**Re: Pacific Northern Gas Ltd. and Pacific Northern Gas (N.E.) Ltd.
Application for Acceptance of 2019 Consolidated Resource Plan and for Acceptance of
Energy Conservation and Innovation (ECI) Portfolio Funding for 2020 and 2022
Response to BCUC Information Request No. 1**

**Pacific Northern Gas Ltd. and Pacific Northern Gas (N.E.) Ltd.
Application for Acceptance of 2019 Consolidated Resource Plan and for Acceptance of
Energy Conservation and Innovation (ECI) Portfolio Funding for 2020 to 2022**

**INFORMATION REQUEST NO. 1 TO
PACIFIC NORTHERN GAS LTD. AND PACIFIC NORTHERN GAS (N.E.) LTD.**

Figure 10 (REVISED): PNG burner tip vs. electricity costs (high carbon price)

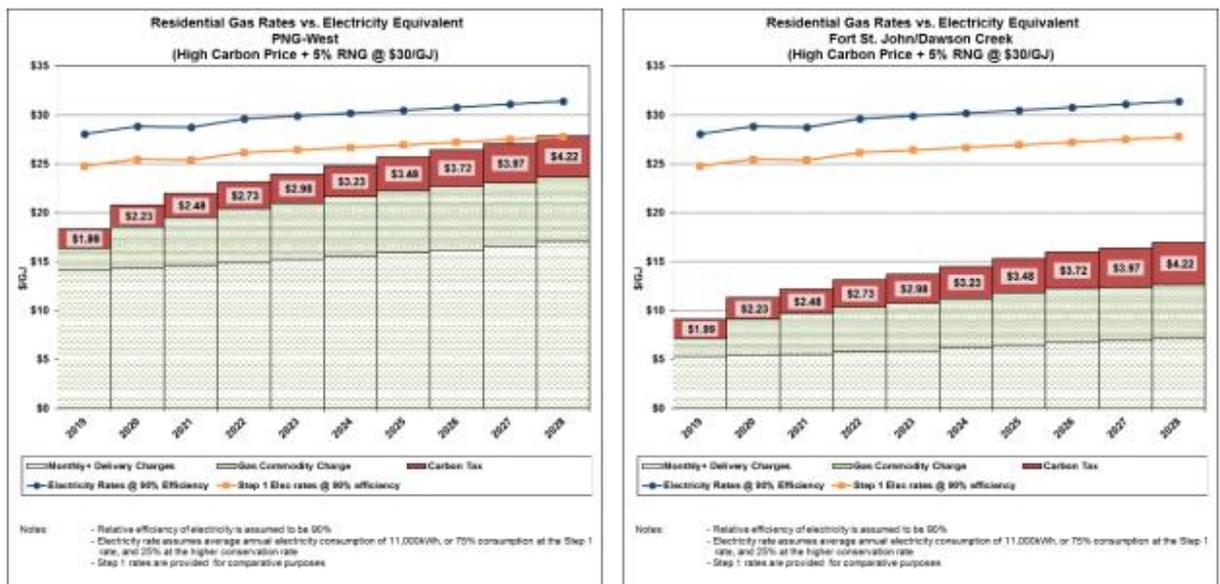
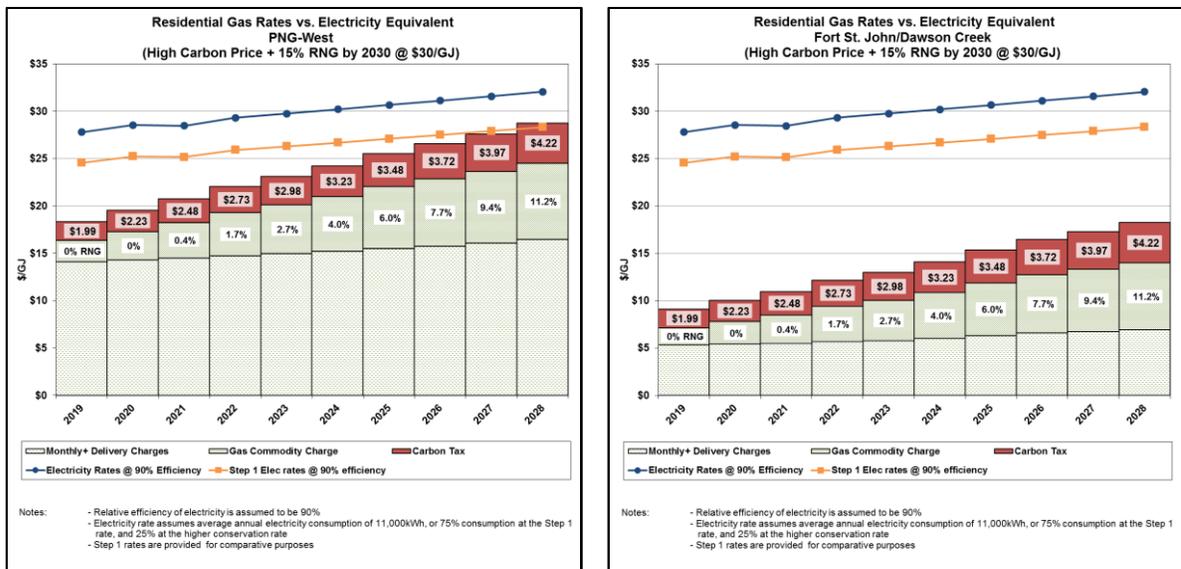
2.1 Please confirm, or otherwise explain, that the RNG supply forecast included in Figure 10 is the same as shown in Table 18.

2.1.1 If not confirmed, please provide an updated graph and/or table.

The RNG supply forecast included in Table 18 is not reflected in the burner tip costs presented in Figure 10.

A revised Figure 10 showing the PNG burner tip vs. electricity costs under a high carbon price scenario that reflects the blend of RNG supply presented in Table 18 is provided below.

Figure 42: Small Commercial Customers (Historical and Forecast) – Fort St. John

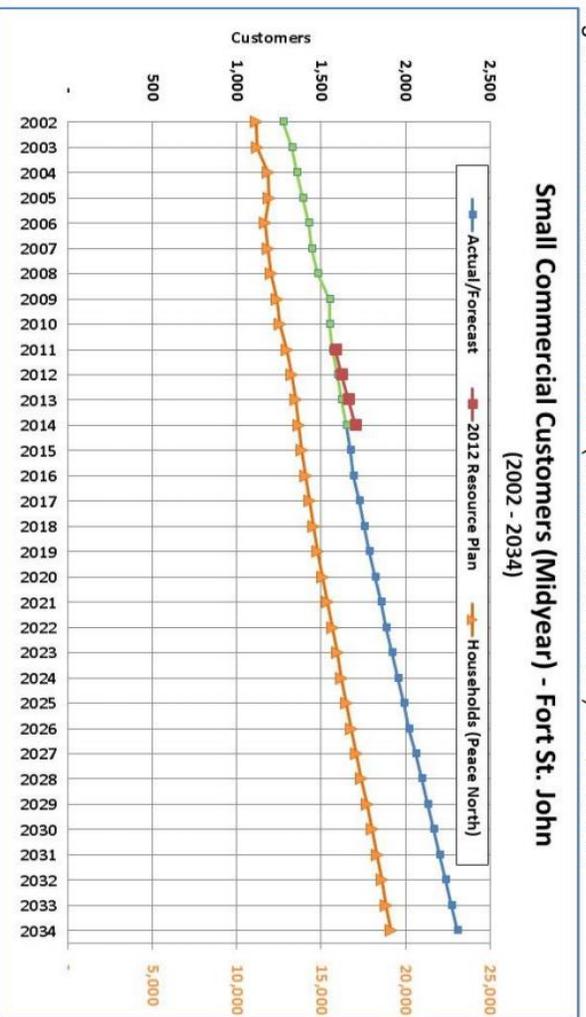
- 16.1 Please provide the most recent correlation analysis between the growth in small commercial customer additions and the trend in household formations for each of PNG's service areas.

16.2 For each of PNG’s service areas, please provide a graph in a similar format to Figure 42 above, demonstrating the historical and forecasted correlation between the growth in small commercial customer additions and the trend in household formations for the period 2002 to 2038. Please include forecasts provided in PNG’s two most recent resource plans.

Correlations between commercial customer additions and the change in households in the corresponding Local Health Area (LHA) remain high in the Fort St. John and Dawson Creek delivery areas. Owing to the small amount of activity in Tumbler Ridge, the correlation between commercial customer additions and the change in households can vary significantly, depending on the time period chosen. While four additional commercial customers were expected over the past five years, based on actual household additions in the Peace River South LHA, Tumbler Ridge experienced no net gain over this same period.

In the PNG-West region, PNG exhibited a net loss of 15 customers, rather than a gain of 30 as forecast in the 2014 Resource Plan that was based on a forecast of household additions in the associated LHA's, and as compared to a gain of 104 customers predicted by the actual household additions over the same period.

Figure 37: Forecast small commercial use per account (Fort St. John)

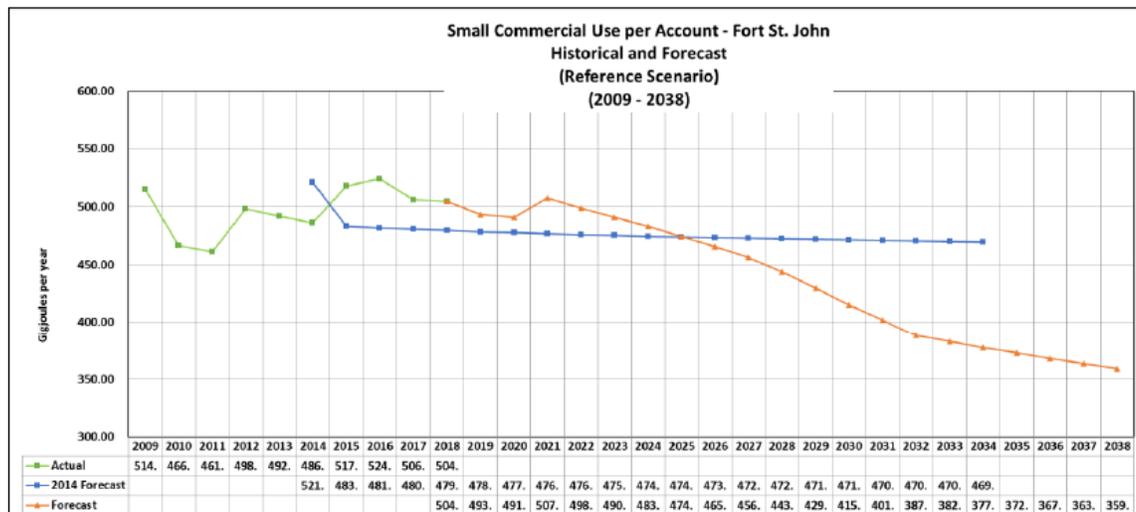
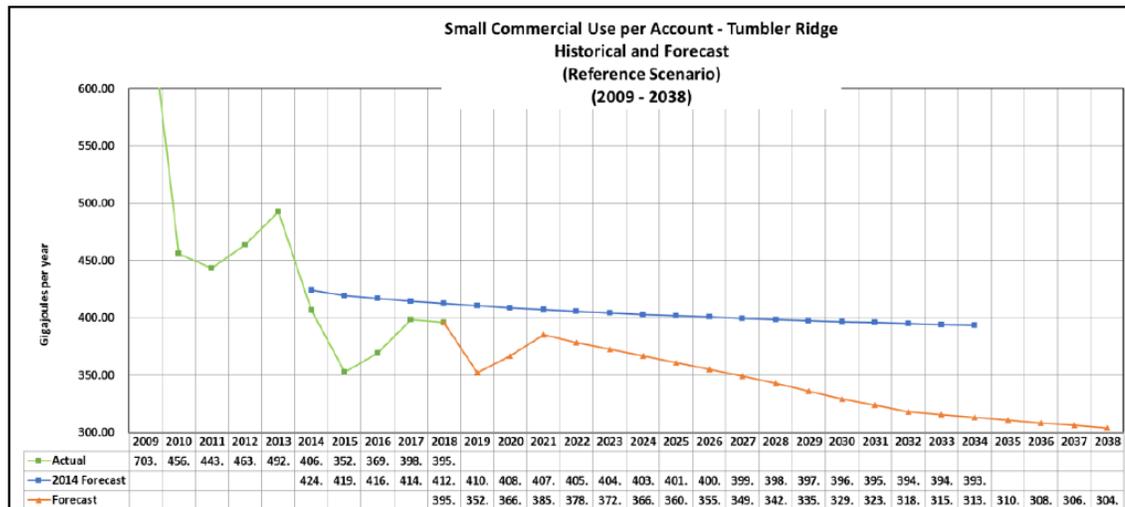
17.3 Please explain the reasons for the forecasted decrease in small commercial UPA for both Fort St. John and Tumbler Ridge.

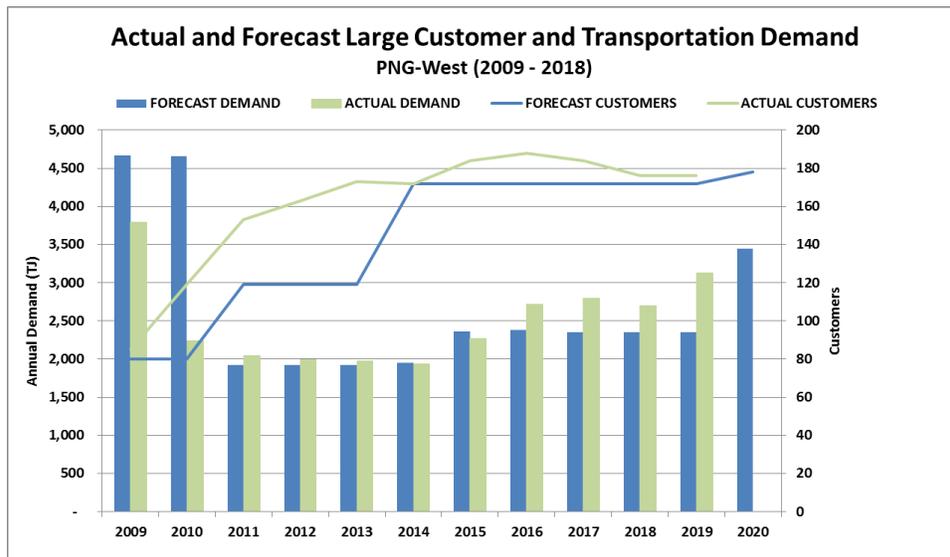
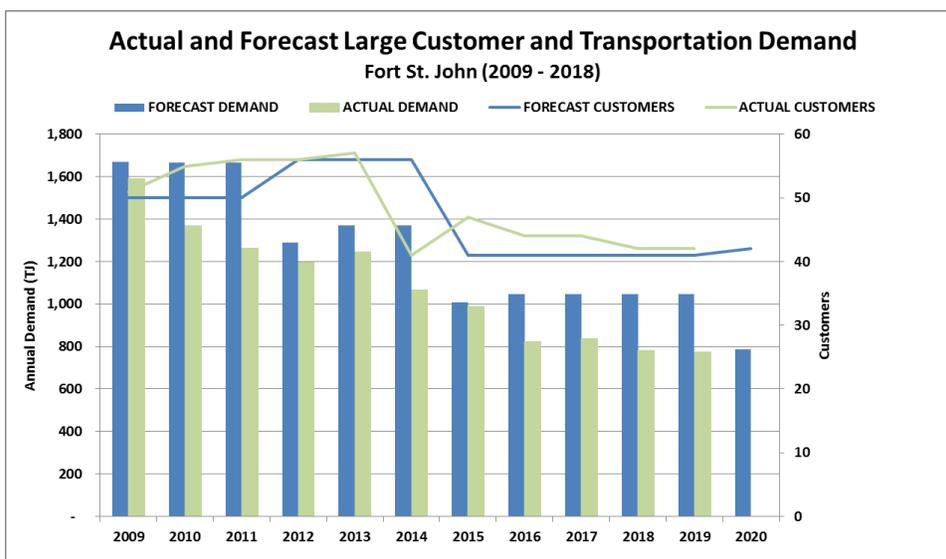
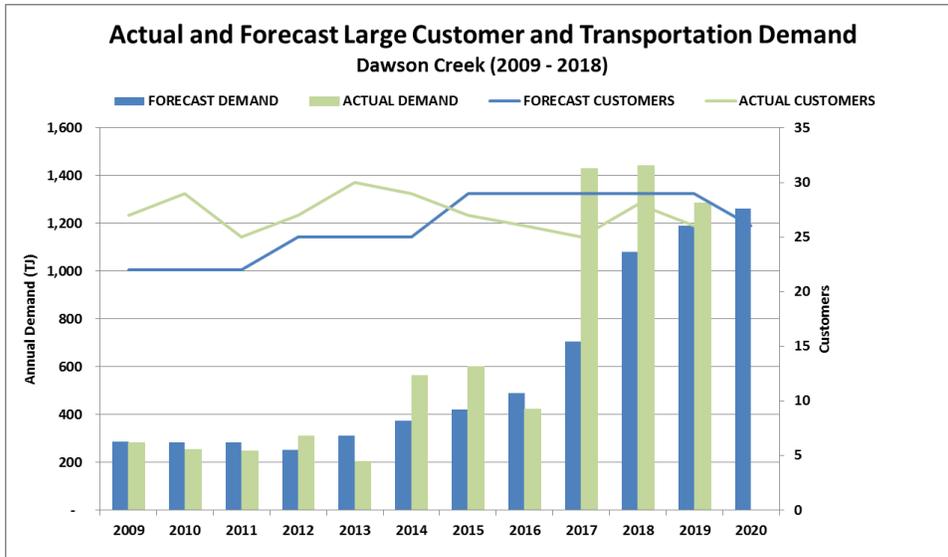
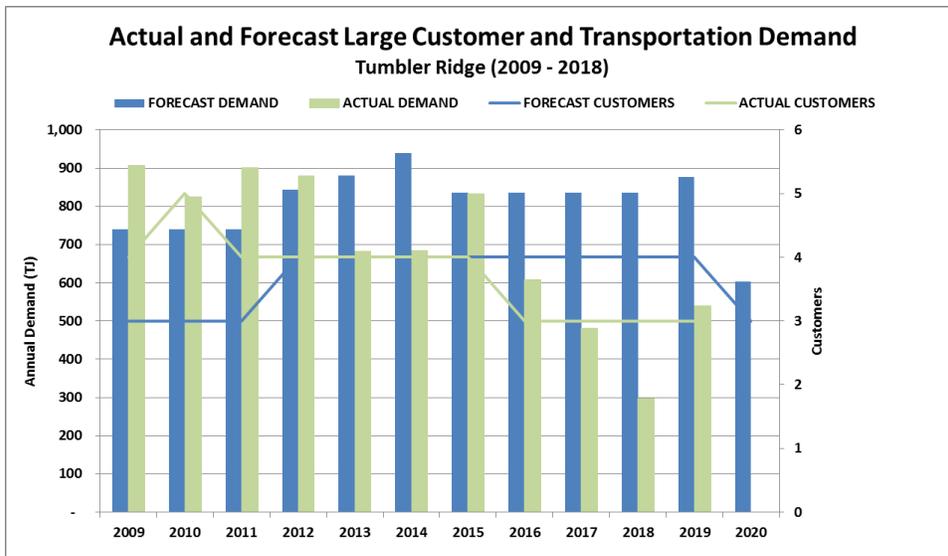
18.2 Please explain why PNG has adjusted some customer forecasts to align with historical operations. Please include in the discussion how previous customer forecasts have compared to their actual demand.

PNG bases its forecast demand from large customers on each customer’s forecast demand for the coming year, and on a review of historical deliveries and anticipated changes in use as gathered from discussions with the majority of these customers. In cases where customer’s forecasts differ from their historical demand, and no changes in the customer’s plant, equipment or operations are anticipated, PNG may, after discussions with the customer, adjust the customer-provided forecast to more closely reflect historical operations.

In January, 2010, one year after the 2009 Resource Plan for PNG-West was completed, Eurocan ceased operation, resulting in a loss of 2,200 TJ per year in throughput. Actual customer counts were notably higher than forecast over the period from 2009 to 2013 owing to higher than expected uptake by existing small commercial customers, of the small commercial transportation service. However, these customers only contribute approximately 50 TJ in annual demand to the Large Customer and Transportation forecast, all of it at the expense of small commercial sales demand and at no impact to the total demand on the PNG-West system. Finally variations between forecast and actual demand over the 2014 through 2019 period is largely due to variations in the demand from the BC Hydro generation facilities located in Prince Rupert. Annual demand from this facility varies widely: from a minimum of 14 TJ in 2011, to a high of 359 TJ in 2019, depending on BC Hydro’s need to supply power to Prince Rupert. PNG has increased the forecast of Large Customer and Transportation demand in 2020 and beyond to account for the demand from new large customers commencing service in 2019 (Skeena Bioenergy and the Ridley Island Propane Export Terminal), and in 2020 (LNG Canada workcamp and the Pembina Watson Island Propane Facility)

Forecast demand over the period 2008 – 2011 is taken from the 2008 Resource Plan for PNG(N.E.), for 2012 – 2014 from the 2012 Resource Plan for PNG(N.E.), and for 2015 – 2019 from the 2015 Resource Plan for PNG(N.E.). Demand for fuel gas supply from oil and gas producers in the Fort St. John area has declined steadily since 2013 as producers shut-in their production in PNG’s service area and focus increasingly on their assets in the Montney formation. Air Liquide, a nitrogen production facility located in Dawson Creek, commenced operation in 2014. Between 2014 and 2019, Air Liquide used natural gas service to supply its own power generation; switching to BC Hydro service in April of 2019 when sufficient capacity from the Dawson Chetwynd Area Transmission (DCAT) line was available. The Campus Energy regional LNG facility in Dawson Creek commenced operation in 2017, increasing deliveries on the Dawson Creek system by 980 TJ.

Forecast demand over the period 2008 – 2011 is taken from the 2008 Resource Plan for PNG(N.E.), for 2012 – 2014 from the 2012 Resource Plan for PNG(N.E.), and for 2015 – 2019 from the 2015 Resource Plan for PNG(N.E.). Changes in the large customer demand is due entirely to the demand for fuel gas by CNRL for its operations in the Murray River area. PNG’s forecast of demand for 2020 and beyond is based on detailed discussions with CNRL on their operations and production plans for the area.

Figure 51: Large Commercial demand – Fort St. John

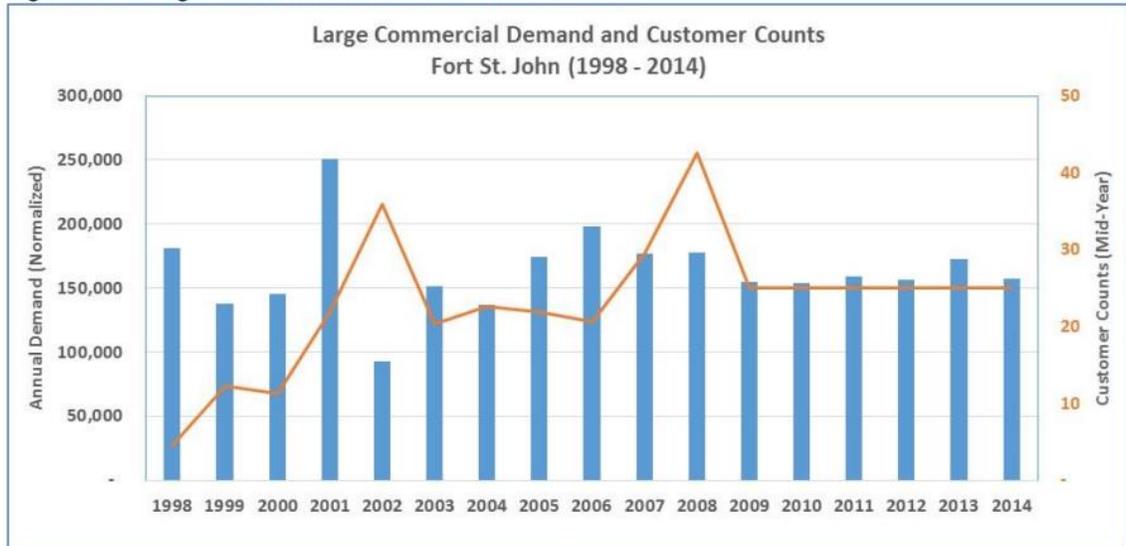
18.4 For each of PNG’s service areas, please provide a graph in a similar format to Figure 51 above, comparing the historic actual large commercial demand and customer counts with the forecasts as provided in previous resource plans for the period 2009 to 2019.

Figure 10: PNG burner tip vs. electricity costs (high carbon price scenario)

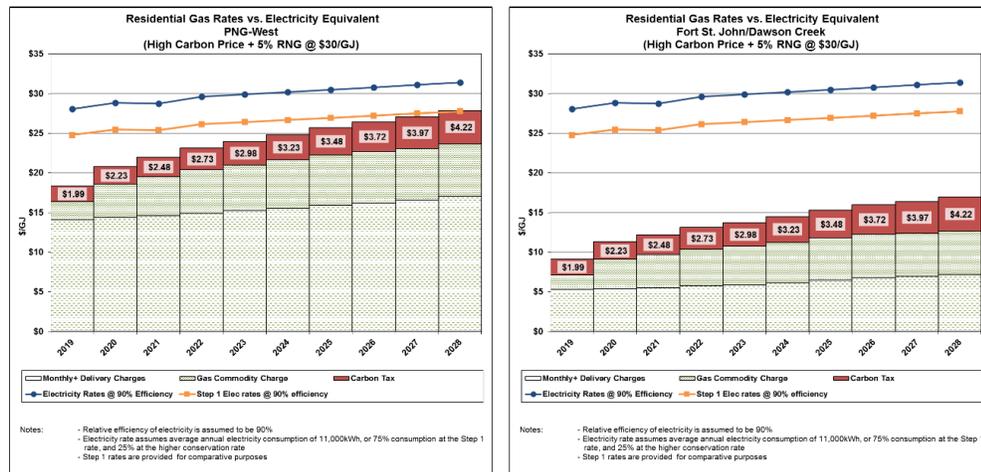
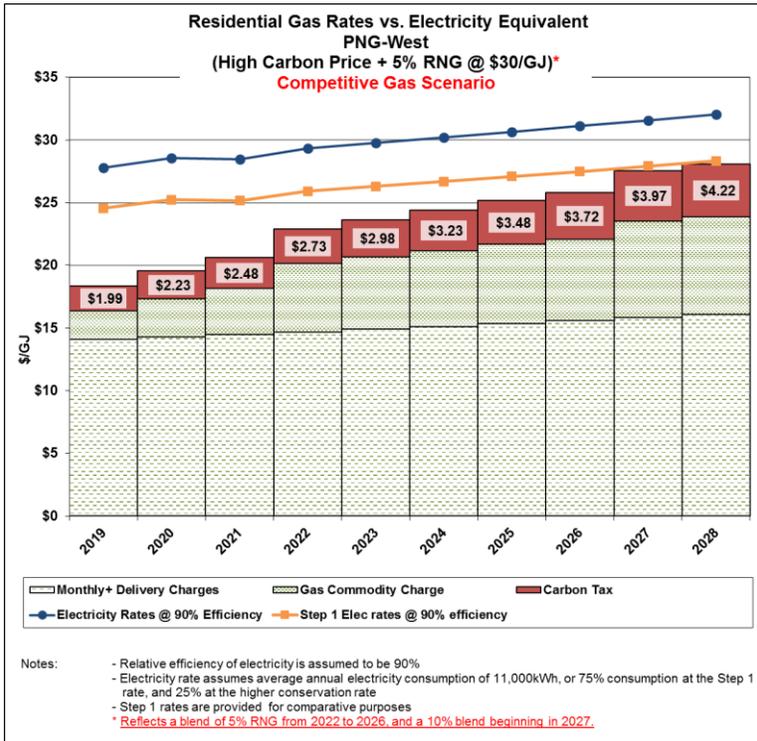
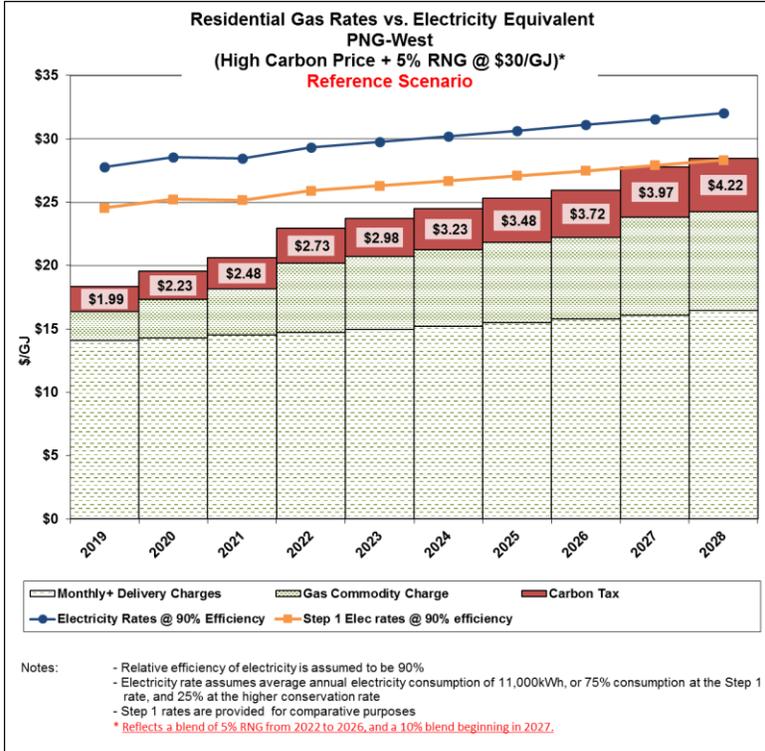
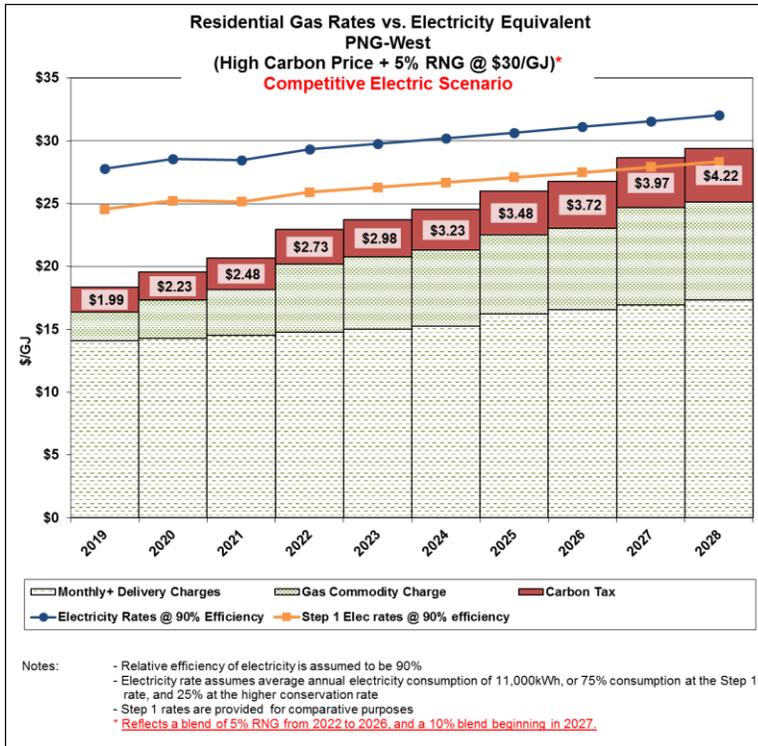
- 32.2 For each service area, please provide a comparison of the natural gas rates versus the electricity equivalents, adjusting the Monthly Delivery Charges to represent the demand forecasts under the Reference, Competitive Gas and Competitive Electricity scenarios. Please provide a comparison for (i) Residential; (ii) Small Commercial Customers; and (iii) Large Customers.

In its comparison of the forecasts of PNG's burner tip rates and electricity costs presented in Figure 10, p. 57 of the Application, PNG has escalated the monthly fixed charge and the delivery charge based on the UPA and system throughput, respectively. Delivery charges are forecast to change in proportion to changes in the throughput forecast for each system, as well as by forecast inflation. This treatment is consistent with how rates are set to recover revenue deficiencies as determined through PNG's revenue requirements applications. The monthly fixed charge is unitized to a cost per GJ, based on the annualized monthly fixed charges, and the annual UPA. Since the UPA is forecast to decline in all planning scenarios, the unitized monthly fixed charge, and therefore the burner tip rate will increase accordingly.

In response to this request, PNG has presented the requested analyses for the residential burner tip rates for PNG-West only. Changes to the forecast UPA and system throughput under each of the planning scenarios are not significant enough to change, significantly, the competitiveness of natural gas with respect to electricity. In Fort St. John and Dawson Creek, the price gap remains significant, whereas natural gas is expected to have some challenges to its cost competitiveness in PNG-West beginning in the later part of this decade.

PNG also wishes to clarify that the "High Carbon" scenario presented in Figure 10, p. 57 of the Application reflects a blend of 5 percent RNG beginning in 2022, and a 10 percent blend beginning in 2027.
